County Plan No.: S-85-97  
Project Name: BUSCH-KINGSMILL EAST SANDY'S FORT  
Stormwater Management Facility: WET POND #2

Re: Kingsmill East - Sandy's Fort  
County Plan S-85-97  
Stormwater Management Facilities - Wet Pond # 2 & # 5  
County BMP ID Code: JR 046 & JR 047

The Environmental Division has reviewed record drawing and construction certification information as forwarded to our office for the above referenced project. The record drawings provide as-built information for two wet pond facilities located near to Andrew Lindsey and George Sandys (roads).

Designed CAH	Drawn GG
Scale 1"=50'	Date 9/19/97
Project No. 7753-6	
Drawing No. 1 OF 4

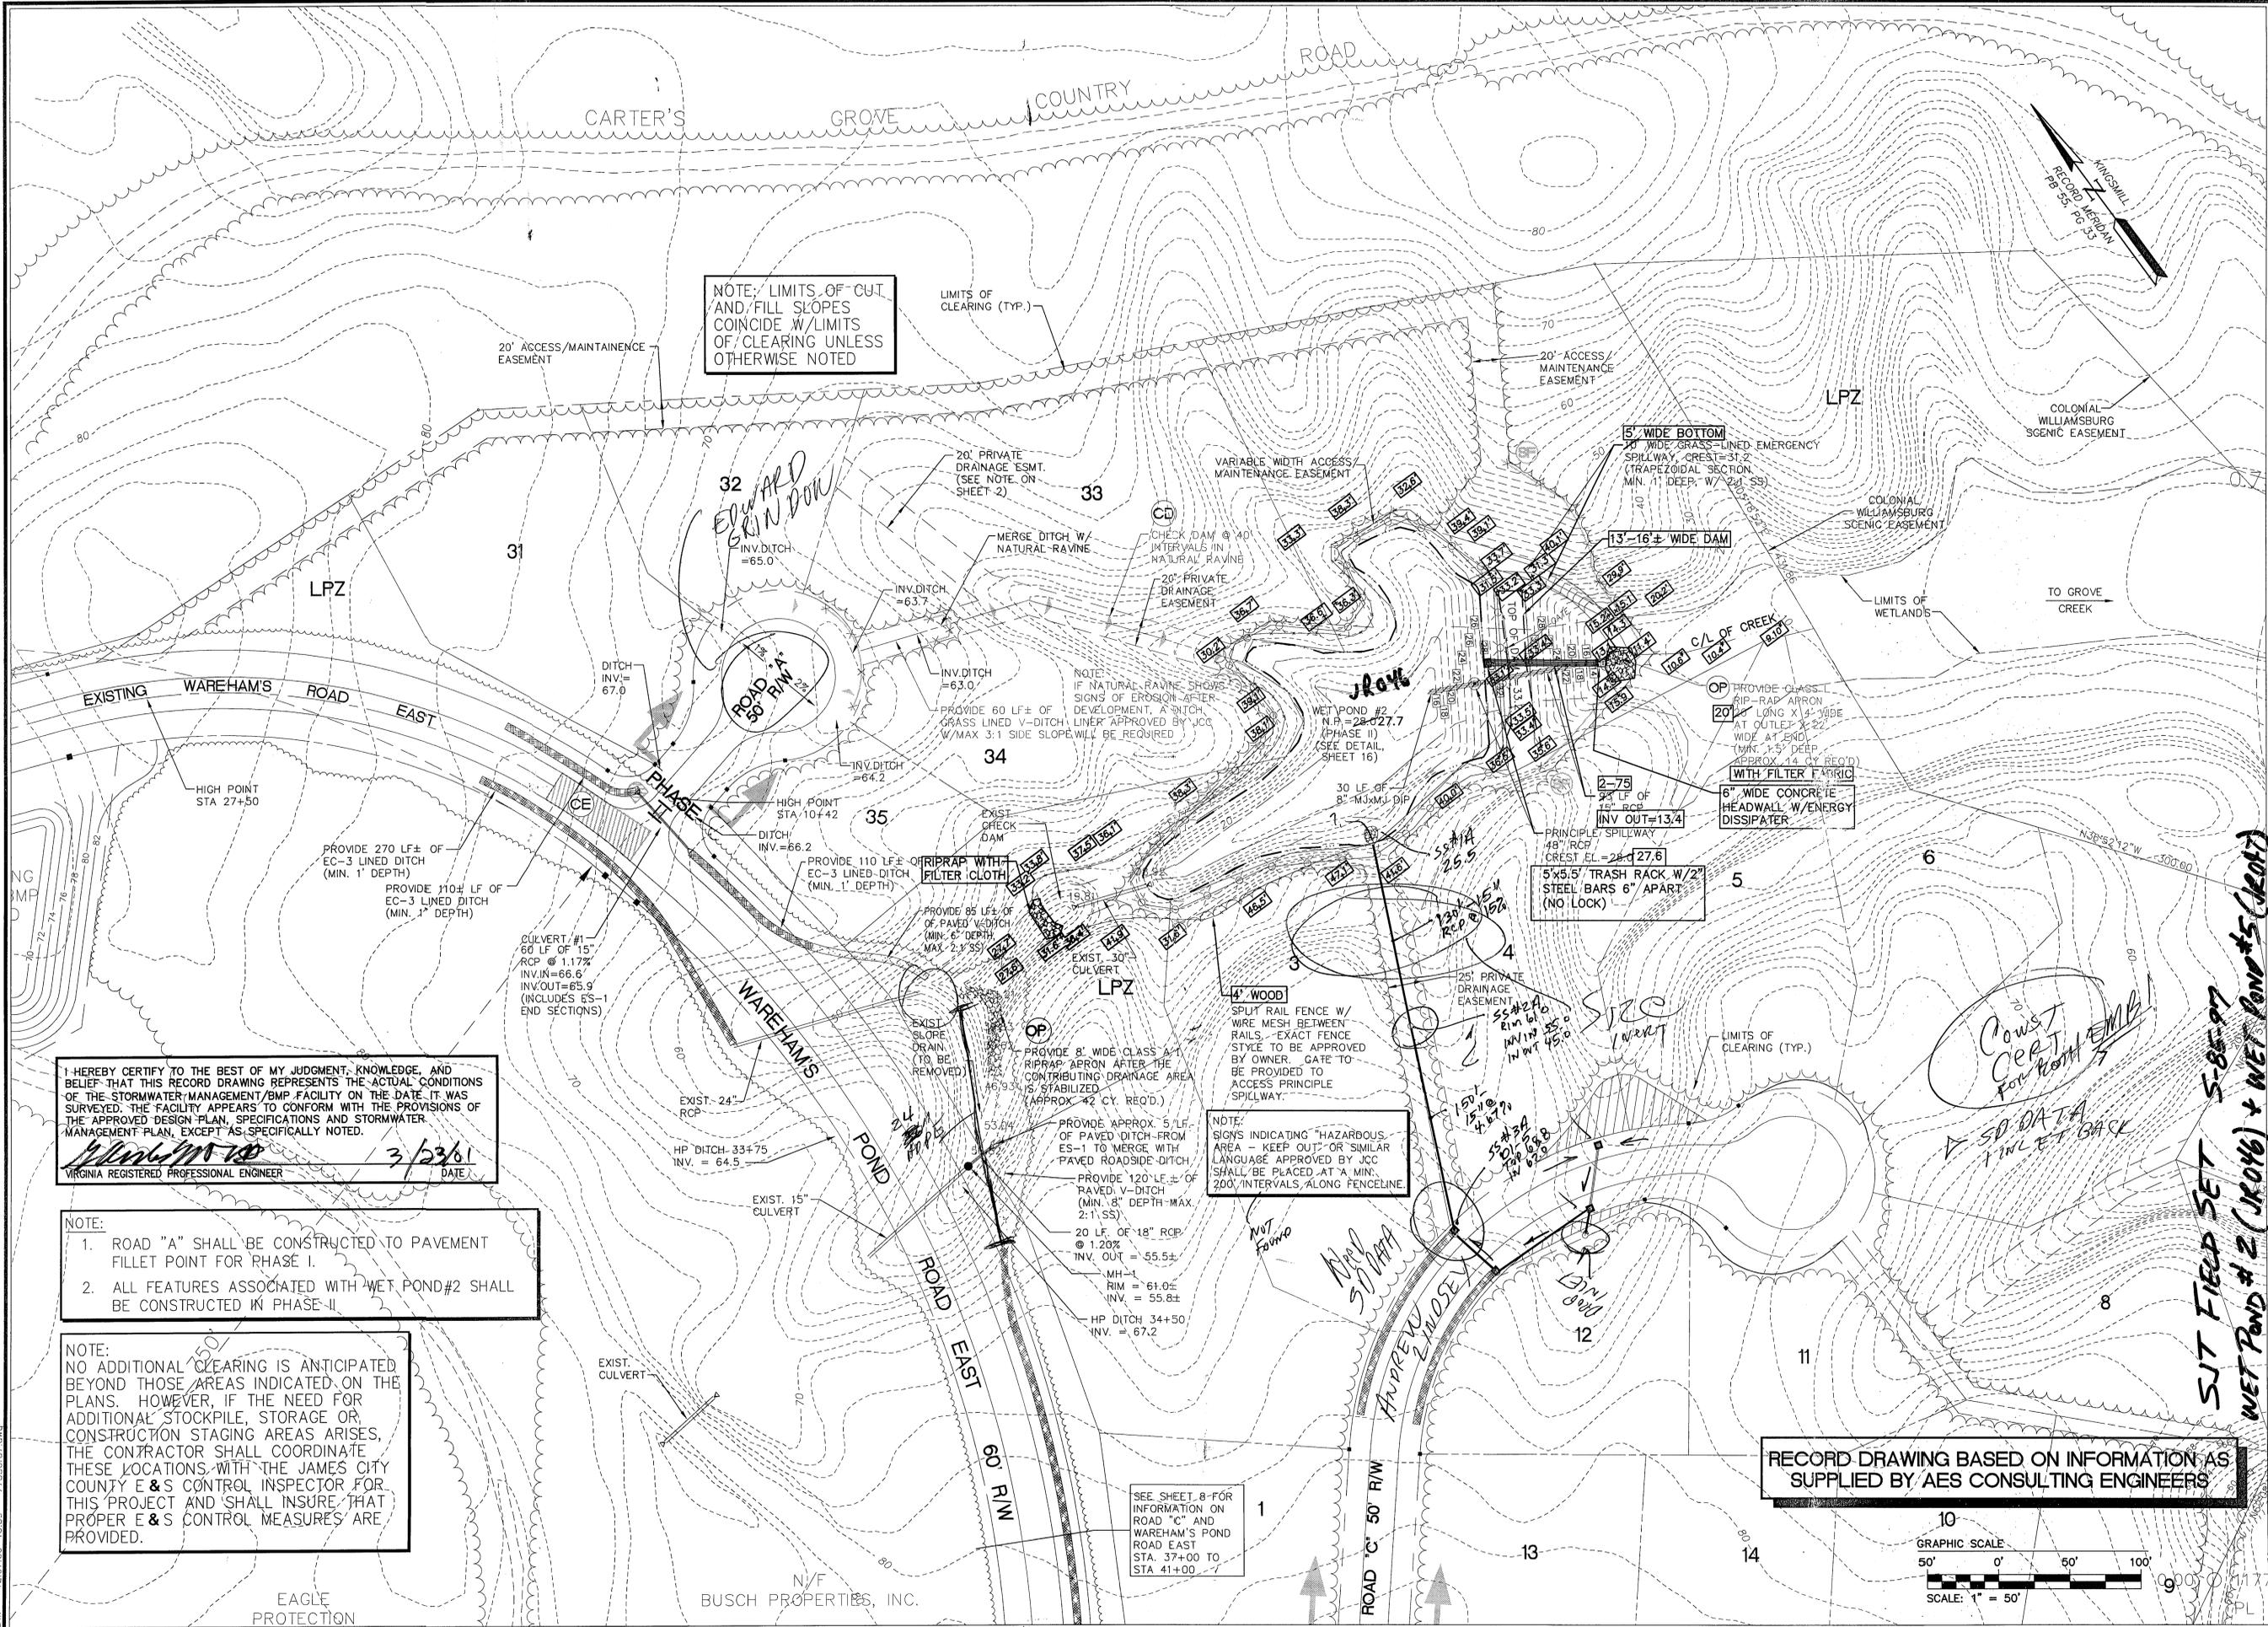
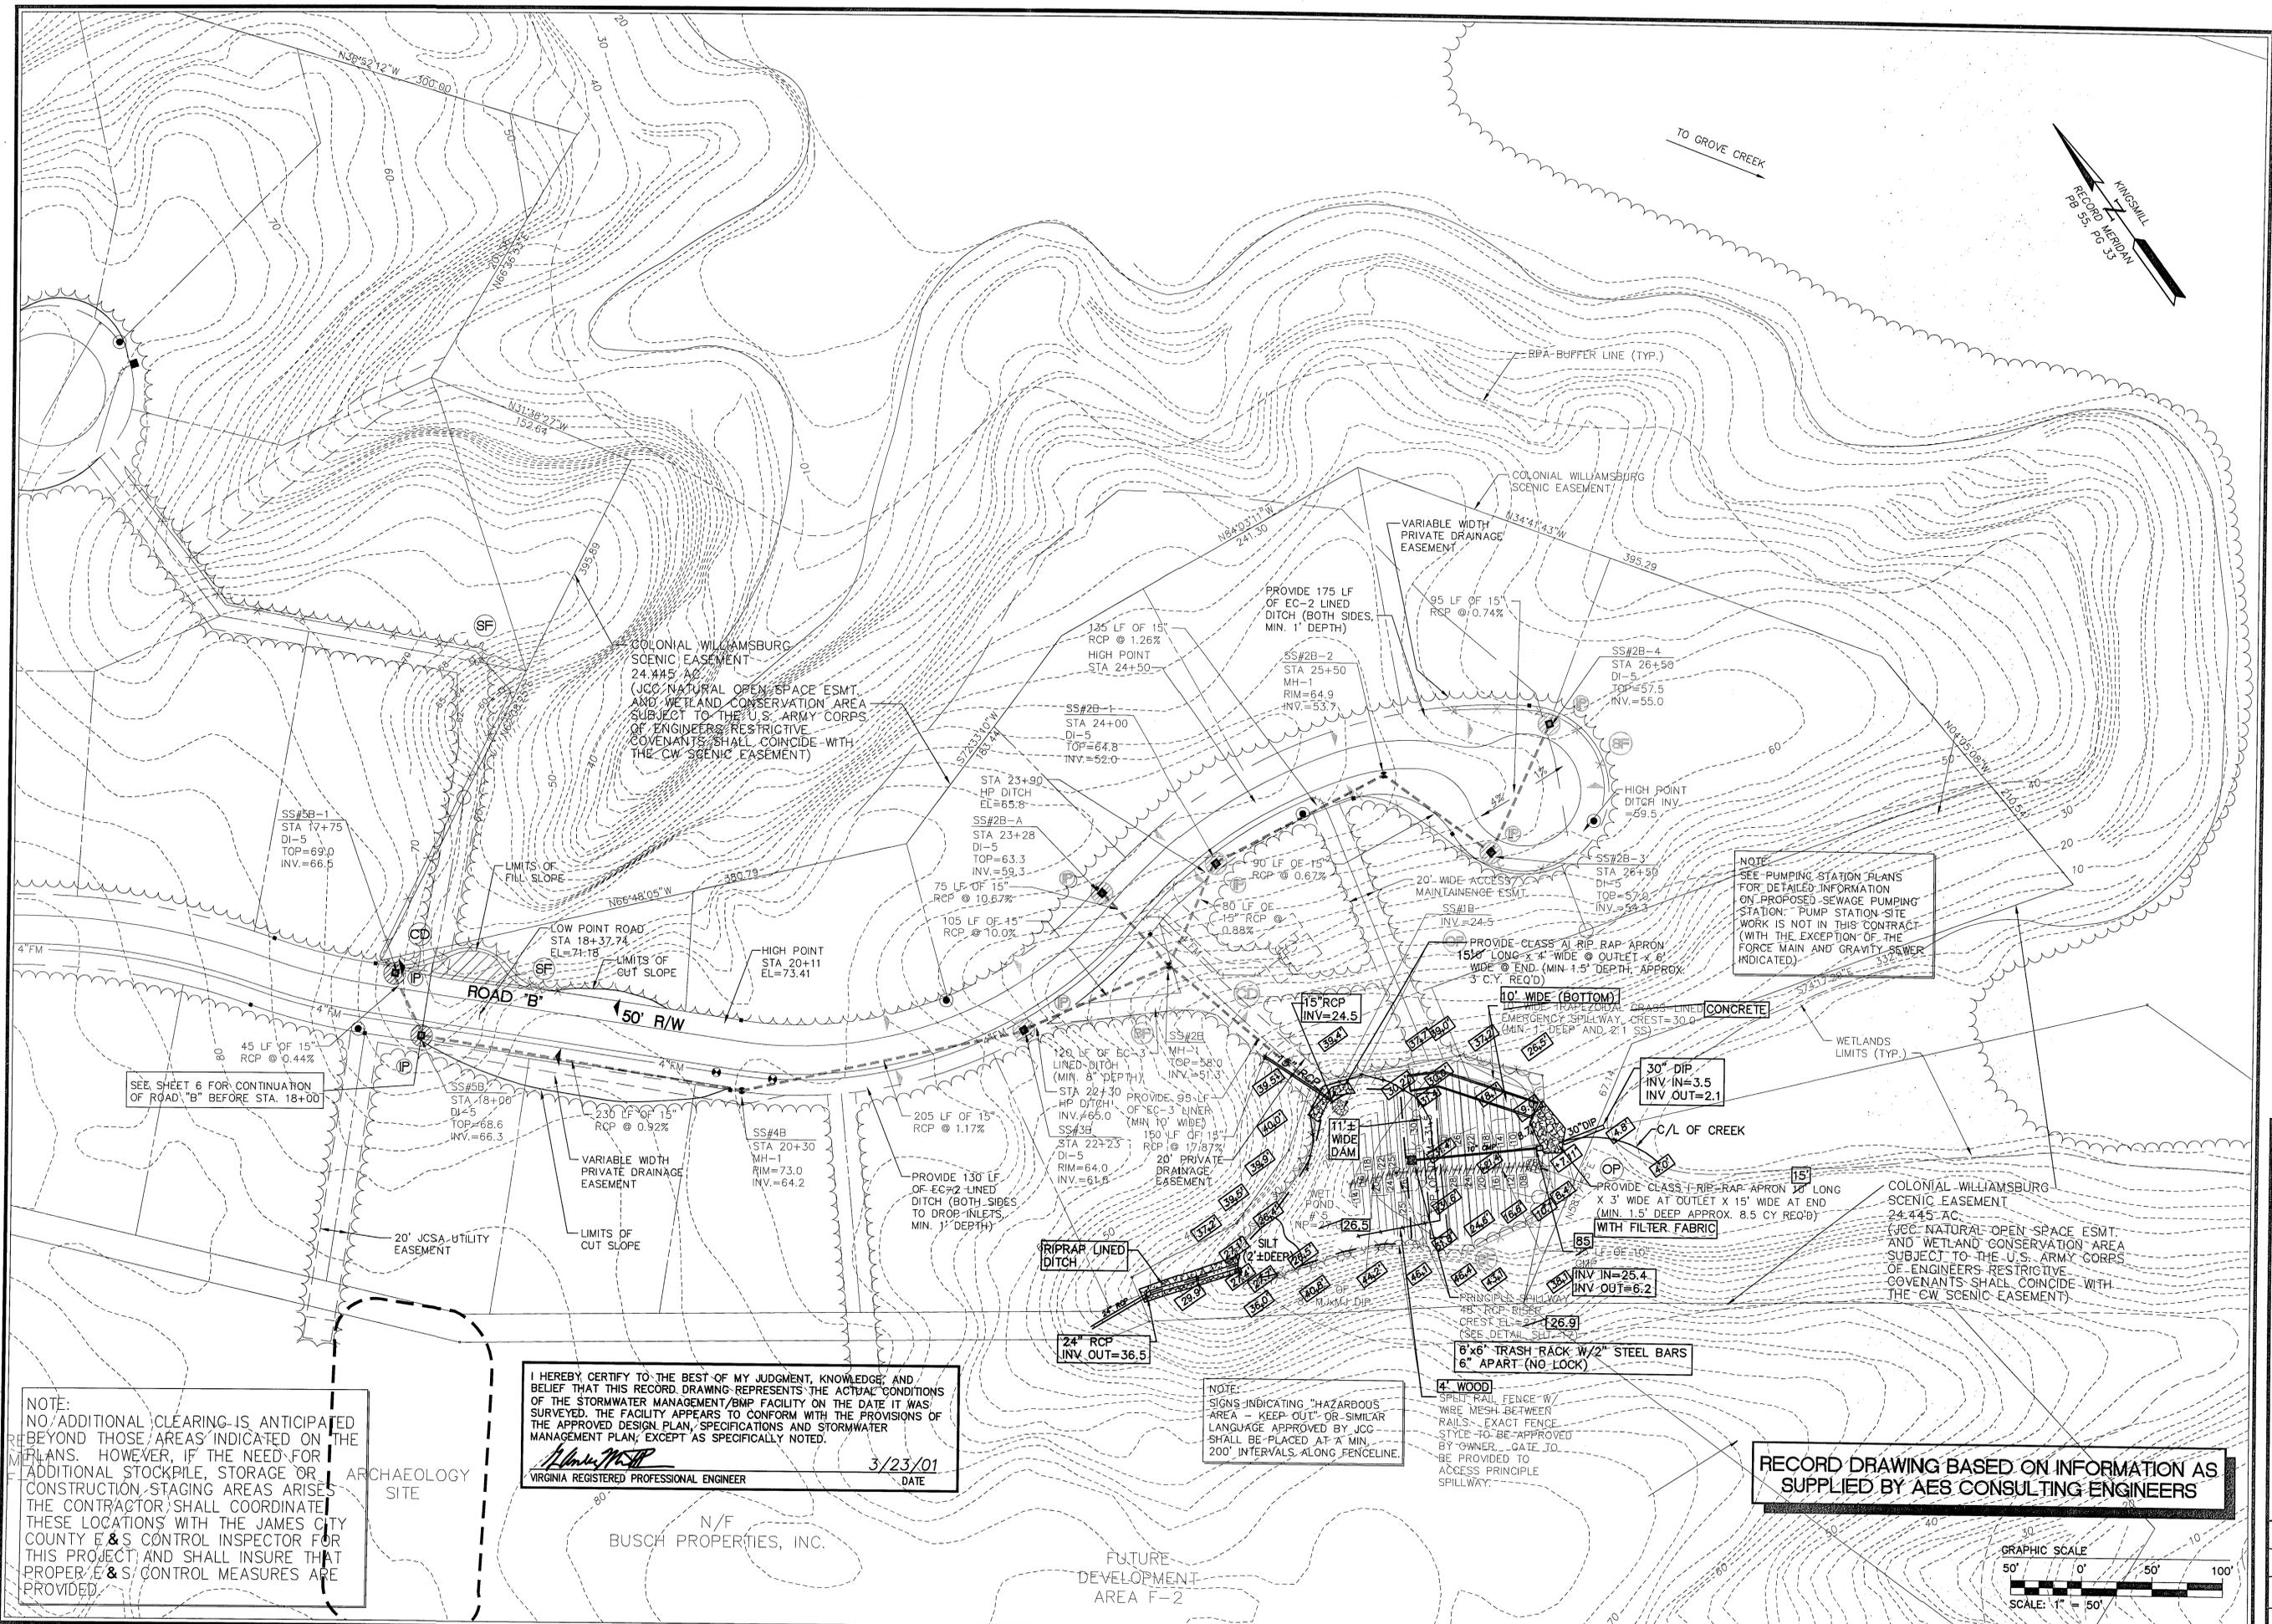
- 3. Wet Pond # 2. Show the following additional information on record drawing Sheet 1 of 4: Construction information for the storm drain pipe system which traverses between Lots 3 and 4 and enters the pond on the south side. Include pipe size, inverts and structure types to at least one structure back from the outfall at the pond. (Note: This system corresponds to storm drainage structures SS # 3a to SS # 1a on the approved plan). Also, if possible, label Road C as Andrew Lindsey and Road A as Edward Grindon.

3. Wet Pond # 2. Show the following additional information on record drawing Sheet 1 of 4: Construction information for the storm drain pipe system which traverses between Lots 3 and 4 and enters the pond on the south side. Include pipe size, inverts and structure types to at least one structure back from the outfall at the pond. (Note: This system corresponds to storm drainage structures SS # 3a to SS # 1a on the approved plan). Also, if possible, label Road C as Andrew Lindsey and Road A as Edward Grindon.

Designed CAH/GAM	Drawn GG
Scale NOTED	Date 9/19/97
Project No. 7753-6	
Drawing No. 3 OF 4

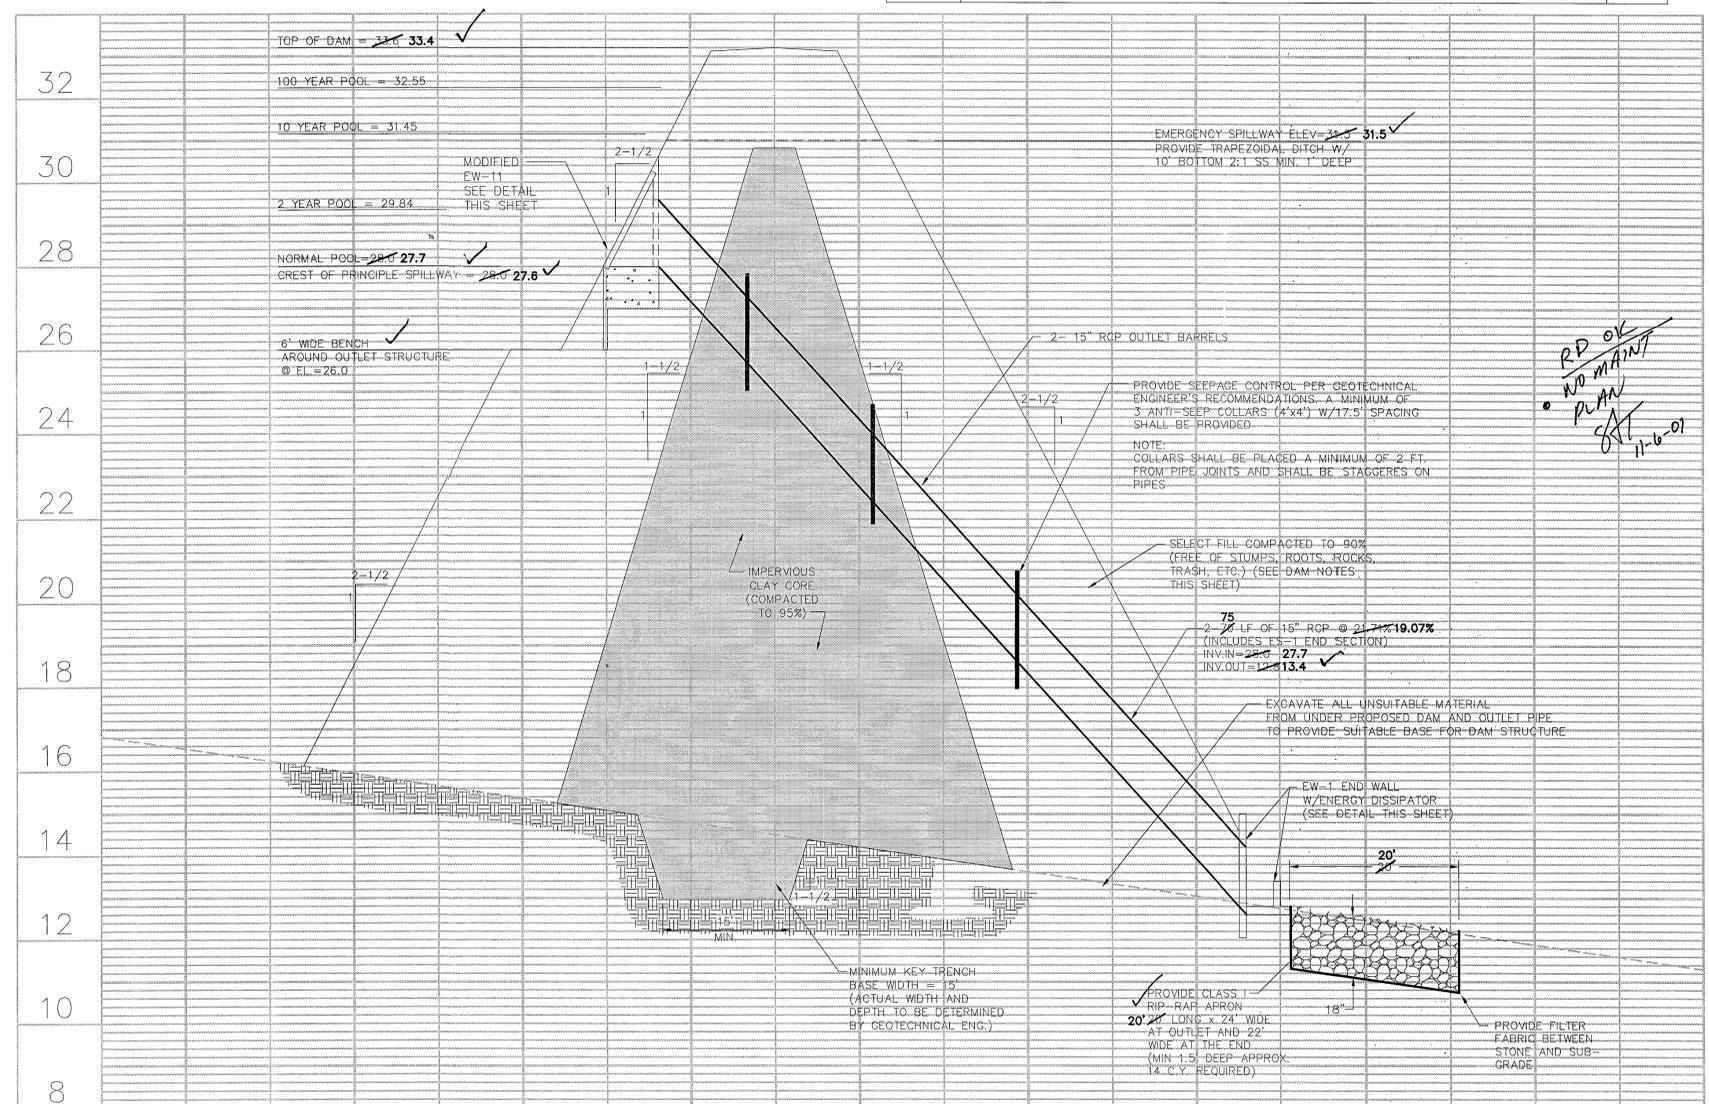
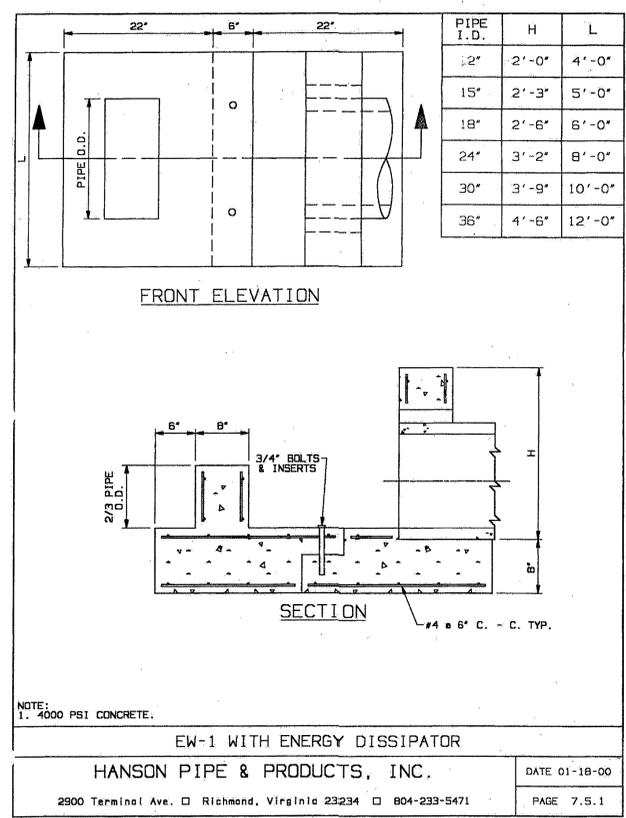
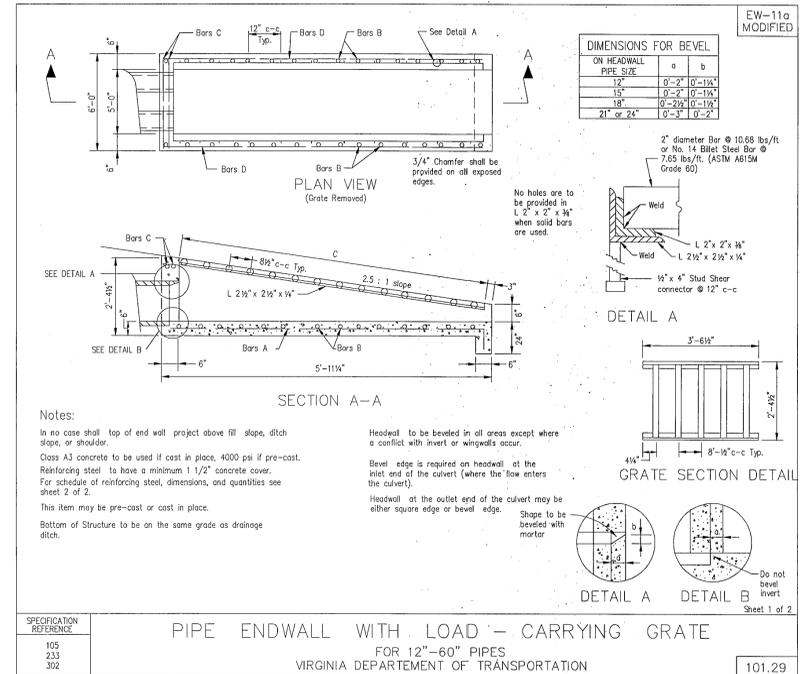
4. If possible add the following identifiers to the bottom right hand corners of the record drawing set: JR 046 to Sheet 1 and 3; JR 047 to Sheet 2 and 4; and S-85-97 to all sheets.
